**CITY & BOROUGH OF WRANGELL, ALASKA**

**WRANGELL MARINE SERVICE CENTER  
CONCRETE PAVING PHASE II**

**ADDENDUM TO THE CONTRACT**

<b>Addendum No:</b>	<b>1</b>	<b>Current Bid Opening Date:</b>
Pages This Addendum:	Four (4)	<b>March 5, 2013 at 2:00 P.M.</b>
Previous Addenda:	None	Previous Bid Opening Date:
		March 5, 2013 at 2:00 P.M.

**Item No. 6** Drawing Sheet E2.01:

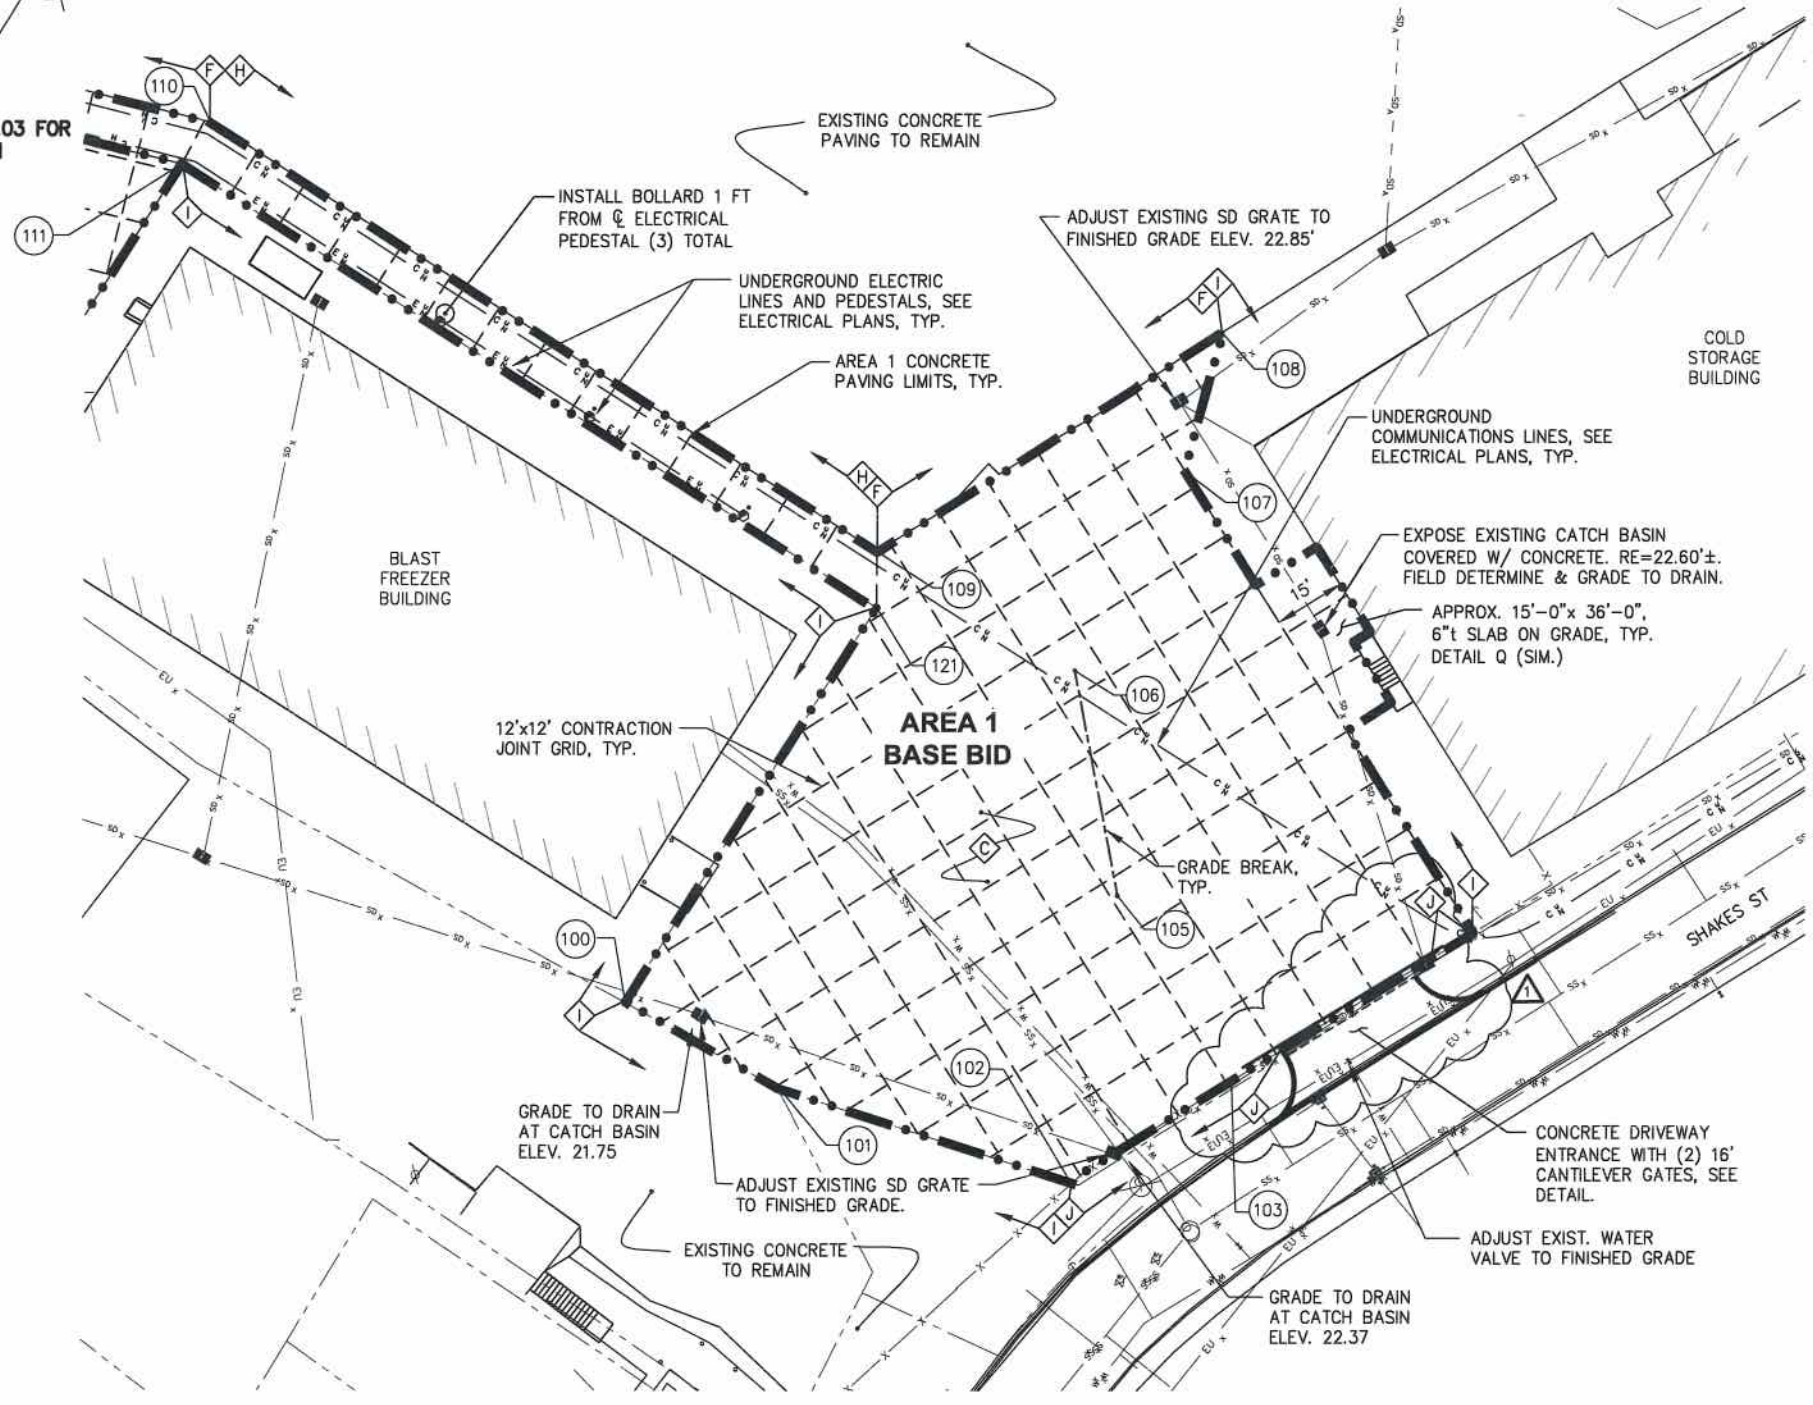
- Revise the conductor size for the circuit between power pedestal no. 4 and power pedestal no 5 from 4 no. 3/0, 1 no. 6 gnd to 4 no. 1/0, 1 no. 4 gnd.
- Revise the ground conductor size from power pedestal no. 4 to Panel S from no. 6 to no. 4.
